Technical Service Bulletin: TSB200067

Fault Code 285/286 Multiplexing

### **Description of Change**

Figure 1, Before Calibration Correction - Insite Is Not Displaying the SAE J1939 Fault Data Screen

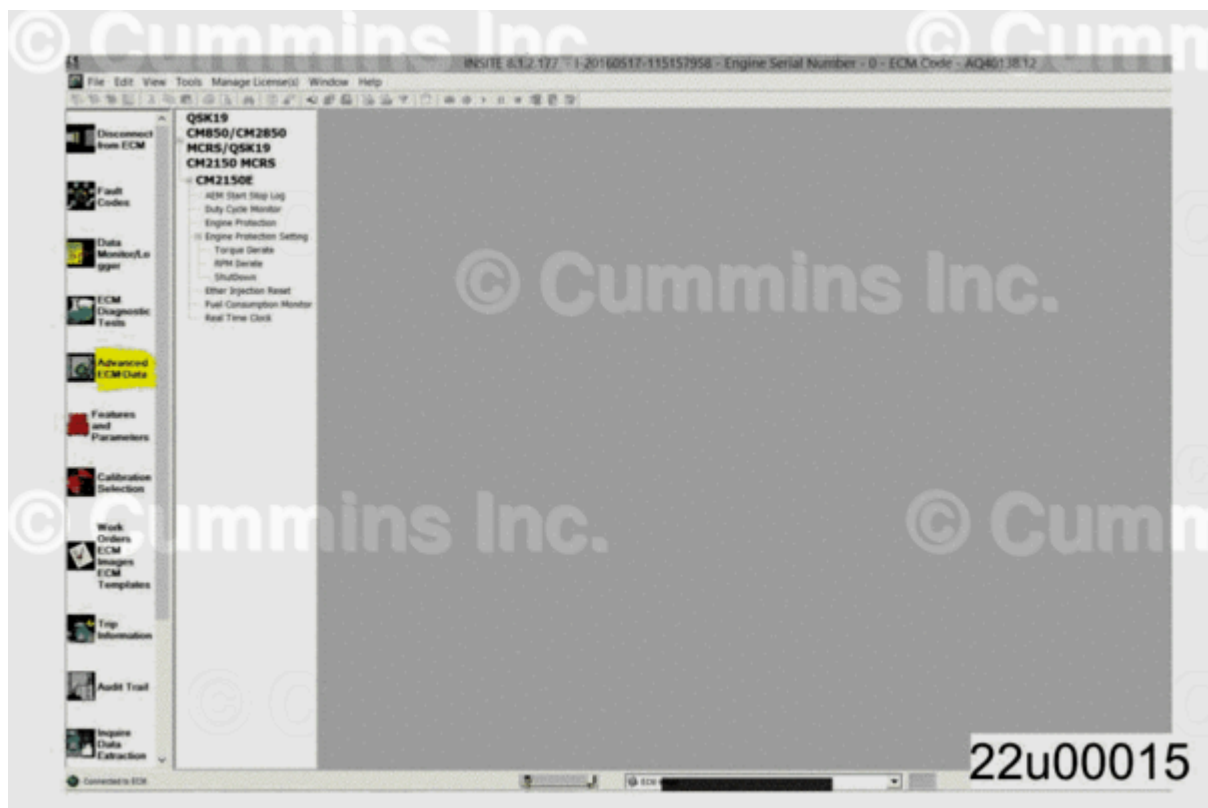
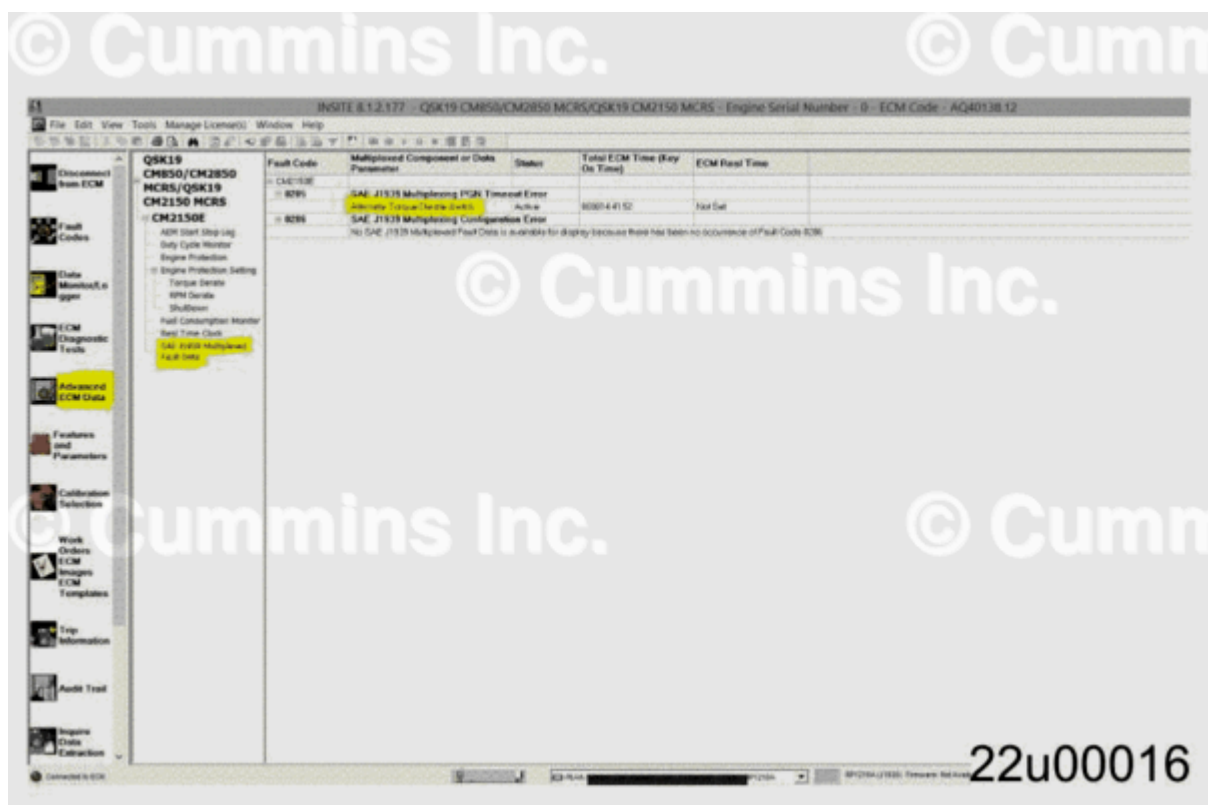
This document announces a calibration correction to enable the display and description of Fault Code (FC) 285 and 286 on the Fault Data screen on Insite.

In the past, the root cause of Fault Codes 285 or 286 has been found to not be viewable on Insite due to a software feature not being enabled on High Horse Power (HHP) calibrations. Fault Codes FC285/FC286 are generated due to a missing J1939 message from the Original Equipment Manufacturer (OEM).

Calibrations have a feature that will display which missing J1939 multiplex message is causing the 285/286 fault code in the Advanced ECM Data tab of Insite; this feature was turned off on various calibrations.

Figure 2, After Calibration Correction - Showing Insite Advanced ECM Data Screen with SAE J1939 Fault Driving the 285 Fault
